## TECHNICAL SERVICE BULLETIN

NO. 180-001

**AFFECTS:** 360-A0

**SUBJECT:** 70729 OIL SEAL

**SUBJECT:** BOW GUIDES BG-14001-A2, BG-14003-B2, AND BG-14001-B2

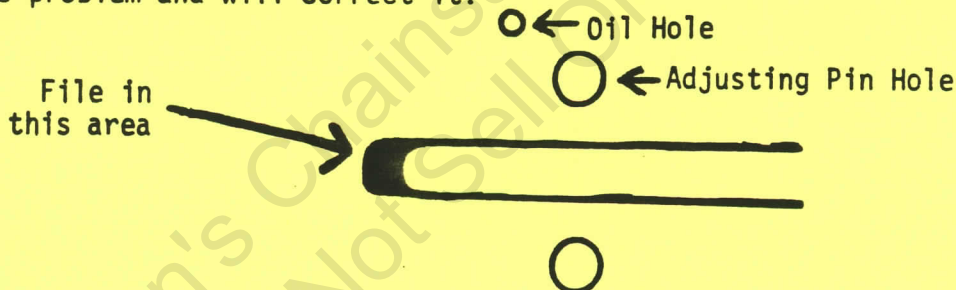
We have had reports that the 38-C50-81 chain is too short and will not fit the BG-14001-A2 bow guide. We have determined that the problem lies in the bow and not the chain.

If you have this problem, simply file out the guide bar slot 1/4". See illustration below. The metal in this area is soft and will file easily. **DO NOT** add a drive link to the chain. The vendor has been made aware of this problem and will correct it.

**NOTE:** It is usually necessary to add an extra inner guide bar shim (70399) when installing a bow guide on a 550. This will assure proper alignment between the bow guide and the sprocket.

To avoid chain interference, replace the existing C-72 handlebar with a new one, designed for bow guides. Order handlebar (A-64727) and mounting screw (80886).

For additional clearance, shim out the bow guide with one or two guide bar plates (58671-B).

Blockage  
Here

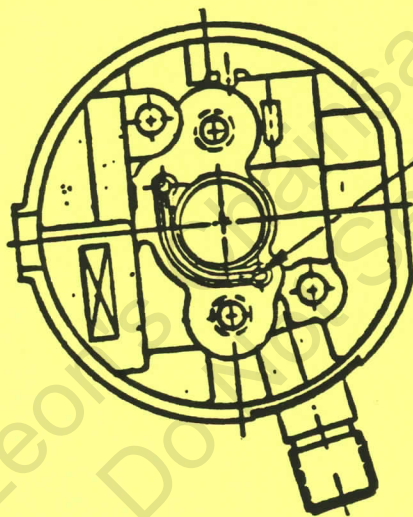
Some A-95327 carburetor housings have been found that have a thin wall of plastic material in the fuel transfer passage (See picture below for location).

This blockage will cause a unit to starve for fuel. These parts have been found in service parts stock in the field. Service parts stock at the B.D.C. has been checked and all incorrect parts have been removed.

Please check your stock. If any housings are found with this wall, it can be broken out with a sharp object.

ST-200/ST-210 BUSHING KIT #A-96064

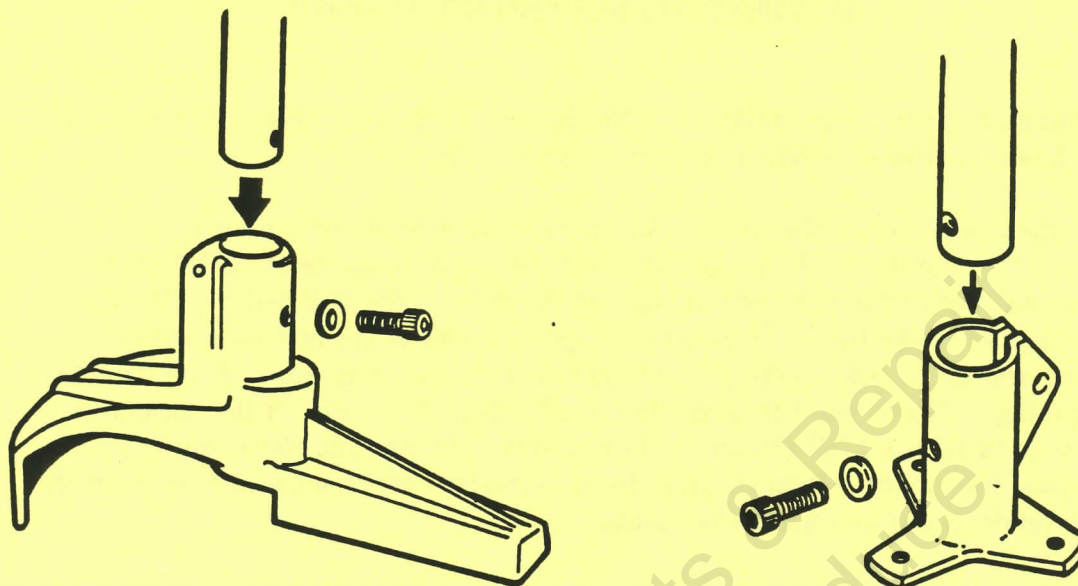
5. Install the bushing in the drive tube. The beveled edge of the bushing goes in first. If the bushing will not slide in the drive tube, tap it in with a plastic mallet. The bushing should not protrude from the drive tube.
6. If the head assembly does not have a large hole in the front of the housing, drill the existing hole out with a 9/32 drill bit (7mm).

**SUBJECT:** NEW STARTER ASSEMBLY

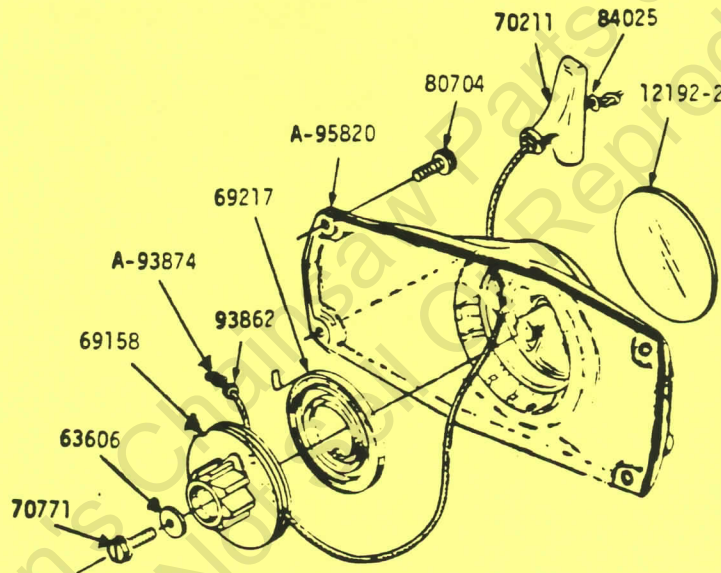
A new starter assembly is being introduced for the SEZ-A0. This new assembly uses a "fiberglass reinforced nylon" starter housing. All new units will have this system. Refer to the parts list below when ordering parts.

This system requires new starter pawls for the rotor. That new part number is 94336. The same rotor, springs, and studs will be used on both the new and old systems. Only the pawls have changed.

**SUBJECT:** CHAIN OILER OILS TOO MUCH

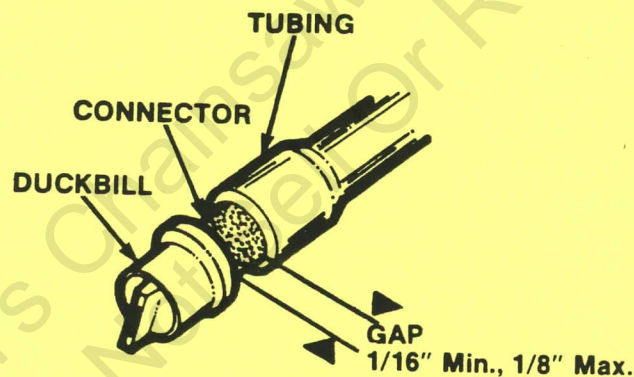
We have found some XL's that build too much pressure in the oil tank. This pressure forces excessive oil to the guide bar.

If a customer complains of too much oil being used during cutting, check the duck bill valve (69451); it may be against the pressure line. Pull the valve away from the line and expose at least 1/16, but not more than 1/8 of the connector (69656-1A).

This will allow the pressure in the tank to "bleed" back through the porous connector, when the unit is returned to idle or shut off, preventing too much pressure from building in the tank. See picture below.

**SUBJECT:** 1. THREE SHOE - LINED CLUTCH  
2. HANDLE BAR

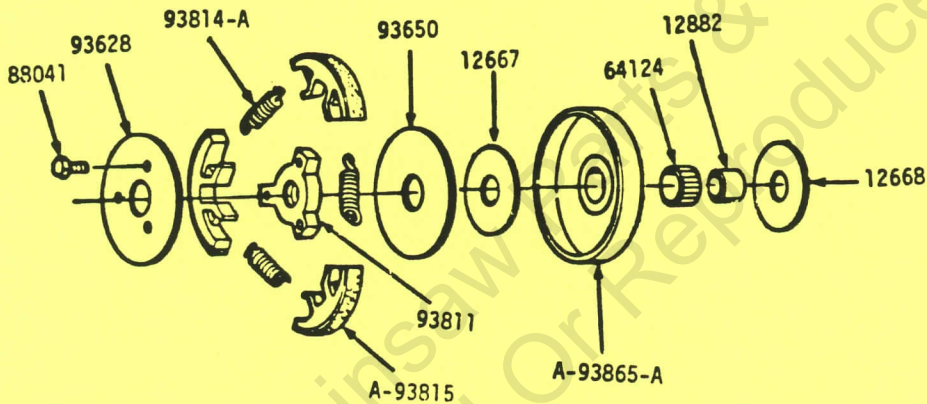
1. The 750-A0 is now being built with the new three shoe lined clutch. Refer to the parts list below when ordering parts.

The parts shown above are also available in a conversion kit, part #A-94157.

**SUBJECT:** BRUSHCUTTER KIT A-94479-A

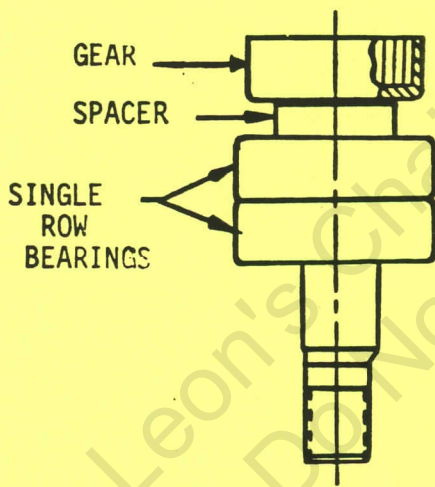
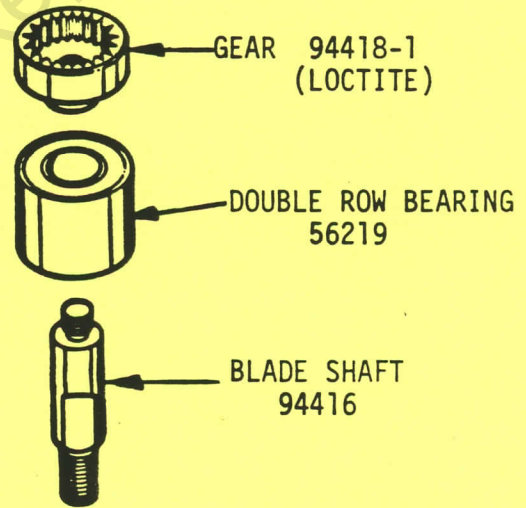
Some brushcutter gear heads (starting with serial number 800015657) have been produced with a blade shaft 94416 that has been assembled with two single row ball bearings and a spacer (see picture below).

We will continue to service the gear heads with the double row bearing as shown below.

**SUBJECT:** A-70532 CRANKSHAFT (BREAKER POINT IGNITIONS)  
A-94712 CRANKSHAFT (SOLID STATE IGNITIONS)

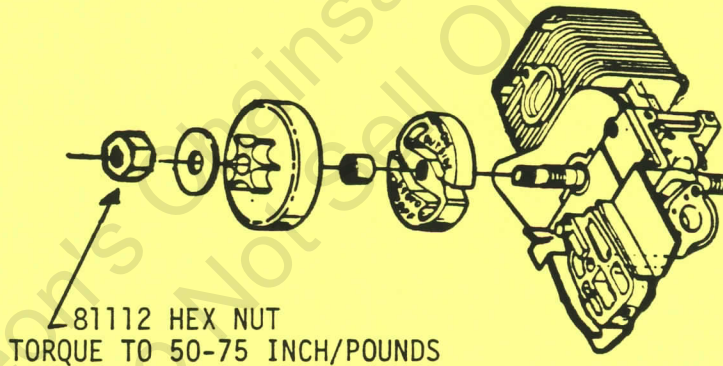
The retaining ring and groove on the clutch end of the above mentioned crankshaft is being replaced by a threaded end and a hex nut (see picture).

Units produced with a serial number of X0290XXXX and above will have this change.

Service will continue to supply the crankshaft with grooved clutch ends until the supply is exhausted. Then crankshafts with threaded clutch ends will be supplied.

**SUBJECT:** WIRES SHORTING ON G SERIES GENERATORS

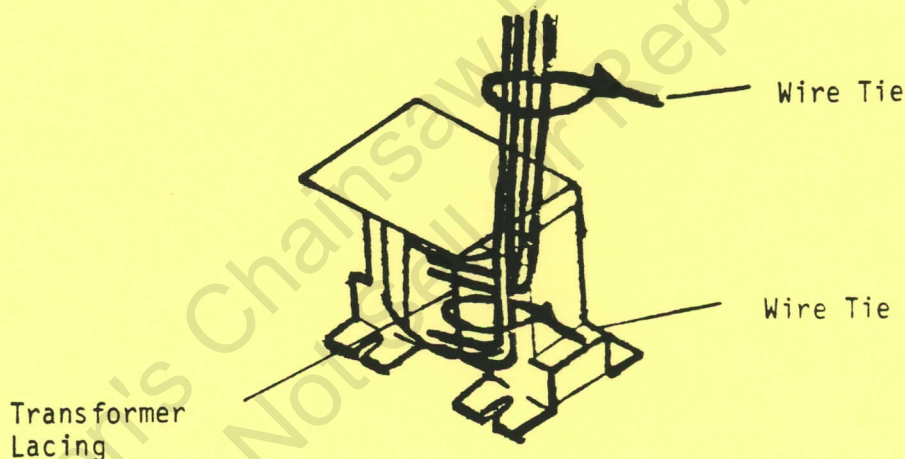
To prevent the transformer wires from shorting on the stator, a wire tie must be installed on the transformer as shown in the picture below. The wire tie will tie the lower wires to the transformer lacing. A second wire tie should be installed on the wire to keep them bundled as illustrated.
